CC MYERS, INC.  
JOB 215 TEMP. BYPASS STRUCTURE

Contract No. 04-0120R4  
04-SF-80-12.6, 13.2  
South - South Detour

Subject: Response to NOPC 6 - PMC Piping and Routing Design

# PMC Piping Plan and Routing Design Submittal, Correspondence and Meeting - Chronology of Events

Subject: REVISED PIPE SUPPORT @ K-RAIL

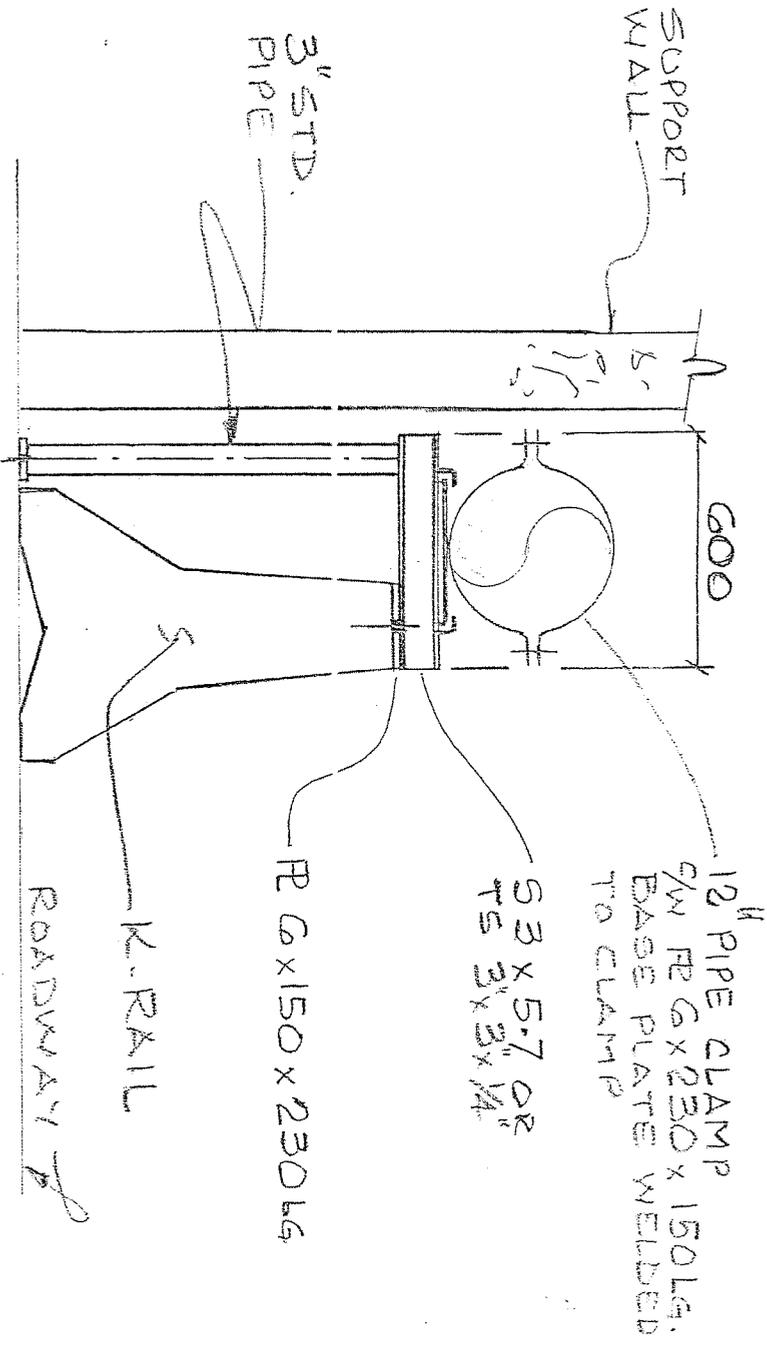
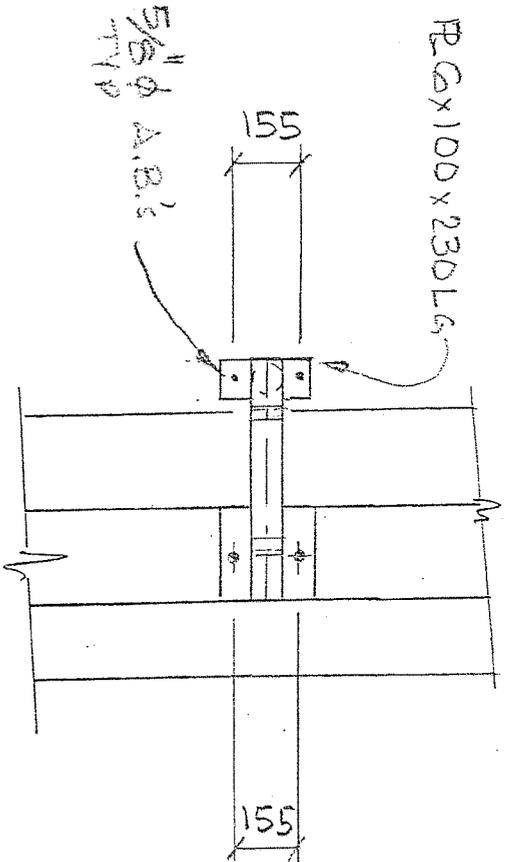
The Department has finished its review of the above referenced submittal. This submittal cannot be approved due to serious concerns regarding the manner in which the pipe is mounted onto both the K-rail barrier and Type 732 barrier rail. Please reference sheets PB-292-104-A and PB-292-106-B of the submittal. It is not acceptable to mount the pipes on these barrier rails, as they compromise the intended safety function of the barrier rails. Barrier rails are not designed to sustain any additional imposed loads on them without modifications to the design. Also, the center of gravity of the altered pipe-rail system would be higher than normal, thereby creating a potentially unstable condition for the barrier rails. Additionally, the sectional drawing on sheet PB-292-106-B shows the centerline of the pipe to be offset with the centerline of the K-rail which would cause an undesired eccentric loading condition.

12" #4' PIPE DEFLECTION ON CURVE  
USING VICTAULIC COUPLINGS.

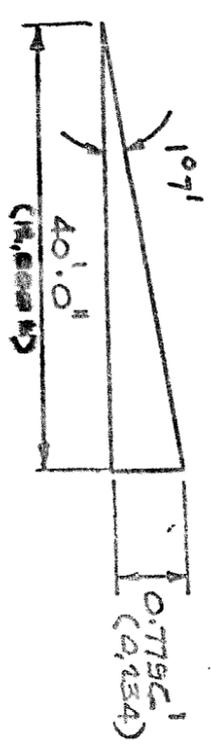
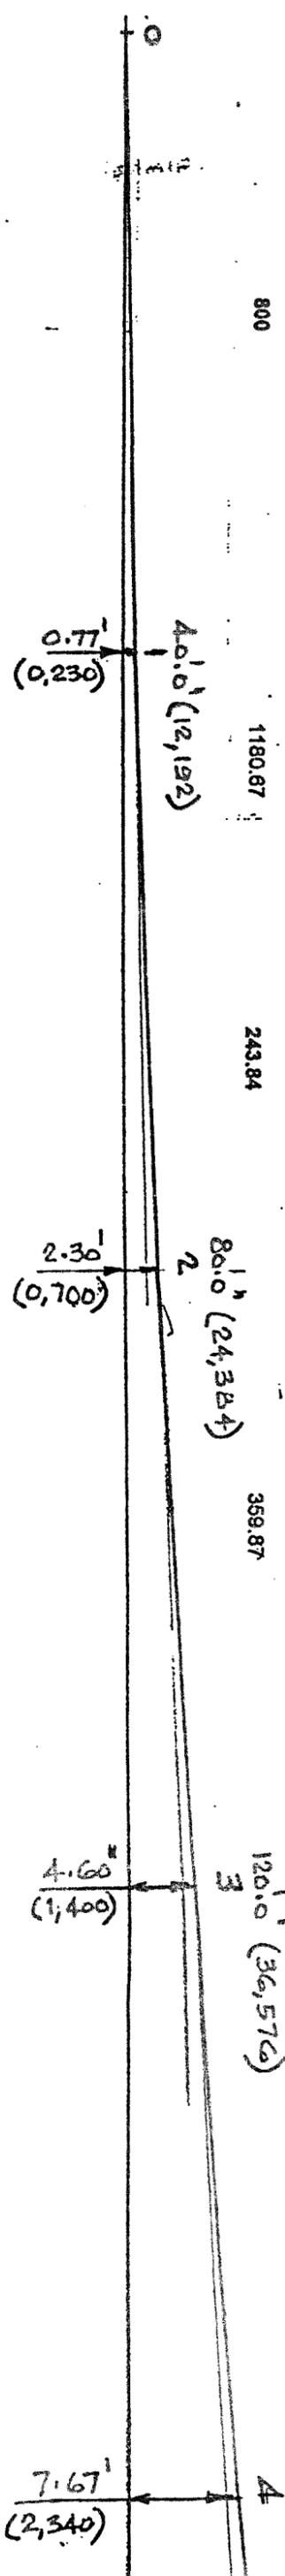
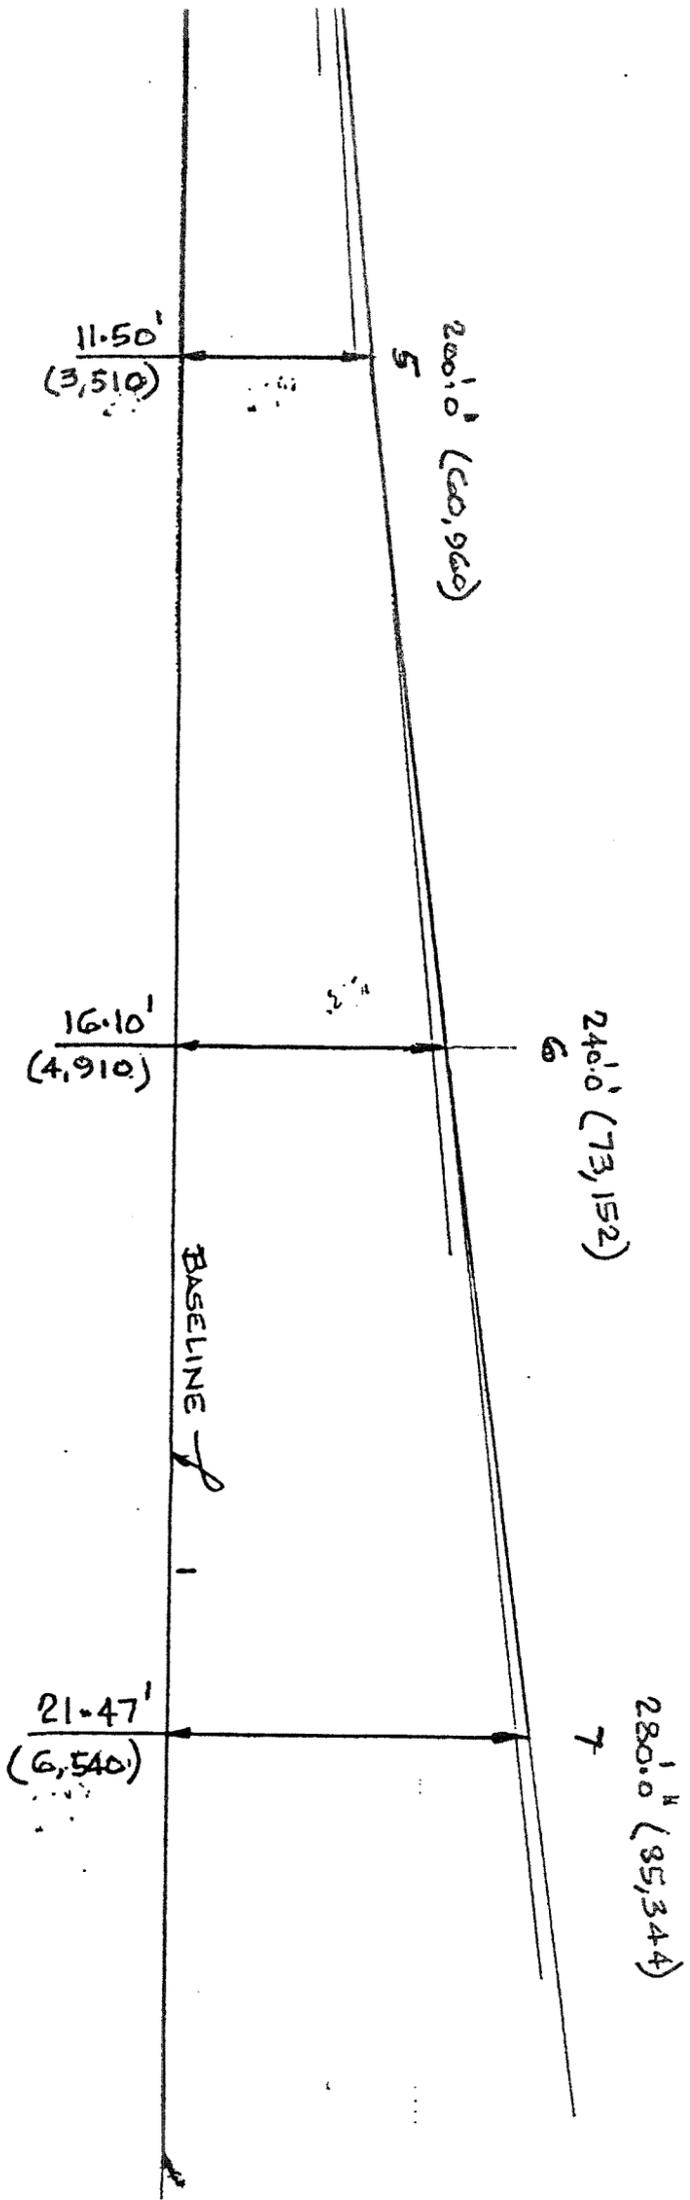
1. Provide specifications for pipe, Victouluc couplings (what type), grooving method, hose and fittings.
  2. Are all the pipes manufactured in 40-foot lengths? Will they be able to match the curves on the bridge with this long of a section?

- 2) All pipe is supplied in 40' lengths, except that a few spools will be cut to size at tie-in or change of directions locations. Note that this pipe has been fully fabricated, galvanized, grooved, inspected and accepted by Caltrans. It is currently stored at Kelly Pipe yard in Santa Fee Springs.  
Yes, the 40 foot lengths will be able to match the curves on the bridge. The flex in the Victaulic couplings provides ample movement for the pipe to curve to match the bridge routing. This had been modeled both mathematically and also graphically. We have attached a copies for your review.
